## V2500 A5 PROPULSION SYSTEMS SERVICE BULLETIN

This document transmits Revision 1 to Service Bulletin EV2500-73-0170

Reason for change  
 To revise Effectivity

ENGINE – FUEL AND CONTROL – TO PROVIDE A NEW A5 SCN16/U ELECTRONIC ENGINE CONTROL (EEC)

Programming Harness Definition Table 1 and Power Supply Connections Table 2  
Figure 2

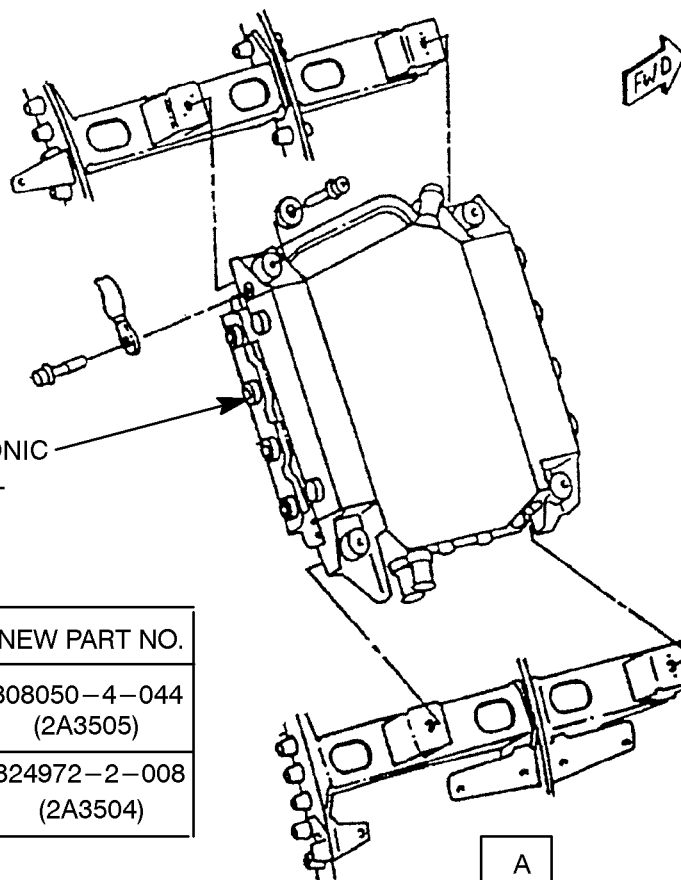
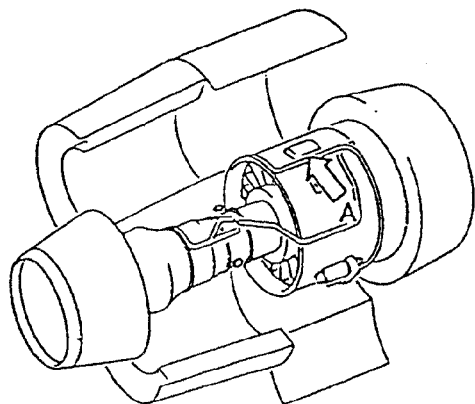
- (3) EEC 150-20 Programming Harness Definition as defined in Table 1 (Figure 2).
- (4) B00T/BITE switches are defined as:
1. Single pole, single throw
  2. Closed contact resistance of 50 ohms maximum
  3. Open contact resistance of 100 Kohms minimum
  4. Closed contact current of 20 mA minimum
  5. Open contact voltage of 20VDC minimum and wired between B00T DISC and B00T/BITE RTN and BITE DISC and B00T/BITE DISC for each channel. Reference Table 1 (Figure 2) for EEC connector pins.
- (5) EEC 150-20/150-40 NAMEPLATE PN 751333-1 or modified nameplate 822815-1.
- (6) 28 VDC +/- 0.5A power supply and associated power cables as defined in Table 2 (Figure 2).

Location of the Electronic Engine Control (EEC)  
Figure 3

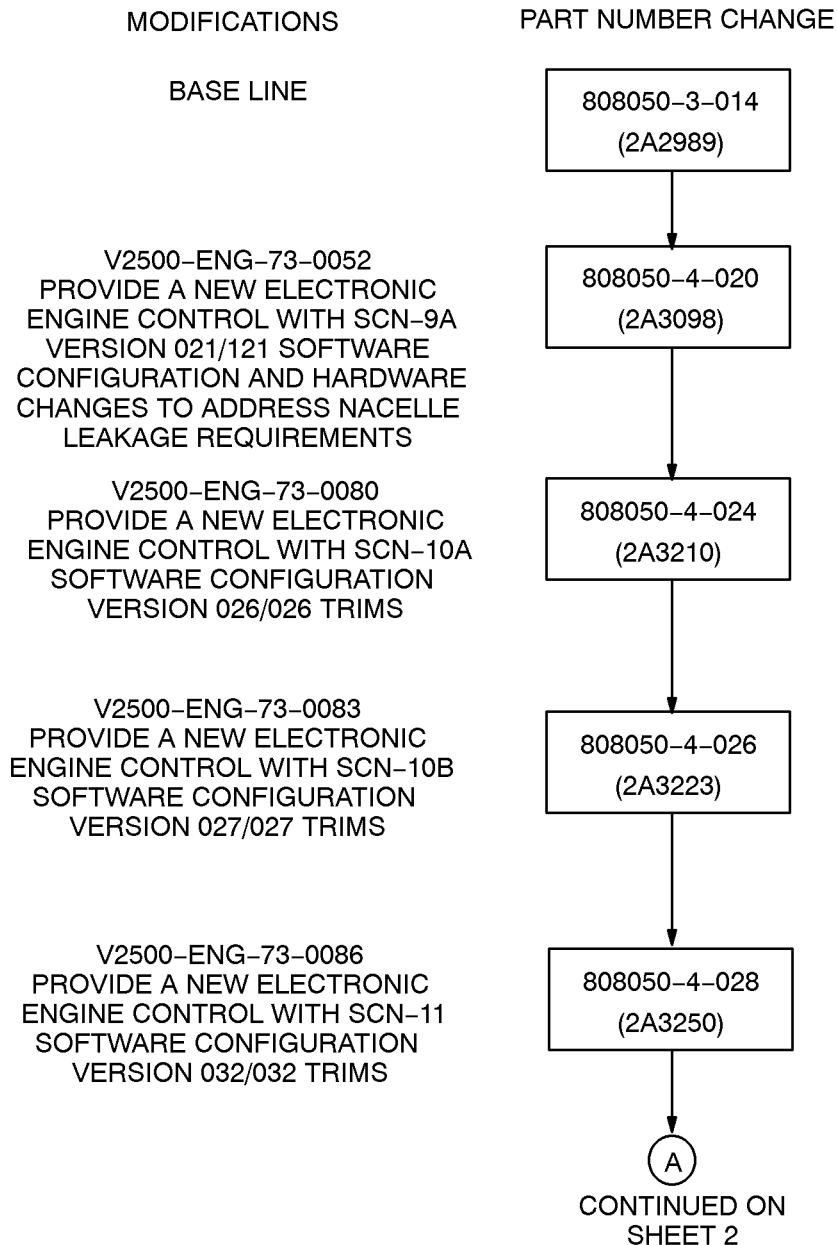
\* REPLACE ELECTRONIC  
ENGINE CONTROL

* EEC	OLD PART NO.	NEW PART NO.
150-20	808050-4-042 (2A3488)	808050-4-044 (2A3505)
150-40	824972-2-006 (2A3489)	824972-2-008 (2A3504)

- (i) Remove the Old P/N (See Table 4 Figure 1 Sheet 10) Electronic Engine Control by the procedure given in Reference (15), Chapter/Section 73-22-34, Removal Installation. See Figure 3.

- (1) Send the Electronic Engine Control to the approved vendor to be modified. See Paragraph 1. A. (1) or (2). See Figure 3.
